PLANNING DIVISION STAFF REPORT

July 27, 2026

Project Address: 4301 Cherokee Drive (10th Alder District – Alder Figueroa Cole)

Application Type: Demolition Permit and Conditional Use

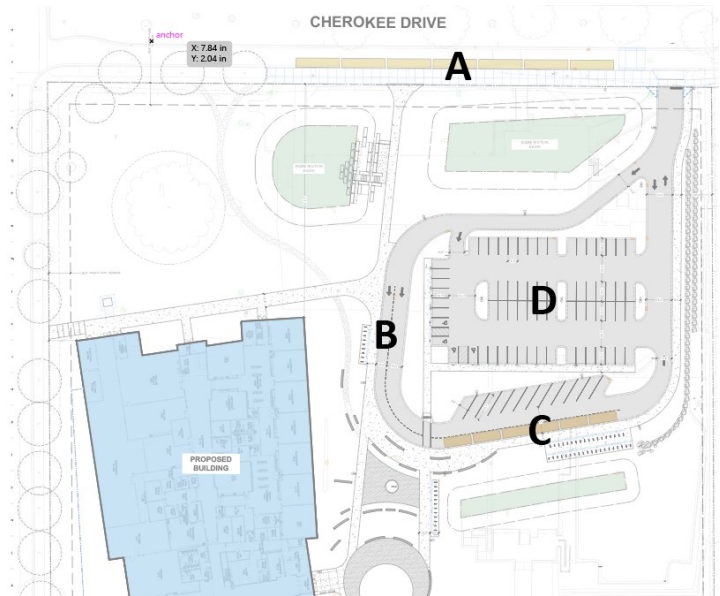
Regarding students and staff getting to and from the school, yellow school buses will stop along the south side of Cherokee Drive (this area is marked “A” in the graphic to the right). In the morning these buses will just drop the students off and then leave while in the afternoon they will typically queue and then load and leave 10 minutes after the bell time of the school. The drop off/pick up area for parents/guardians in personal vehicles is marked “B” in the graphic while “C” indicates the loading zone for Paratransit. Finally, the central parking lot, indicated by “D” in the graphic, is for staff and visitors.
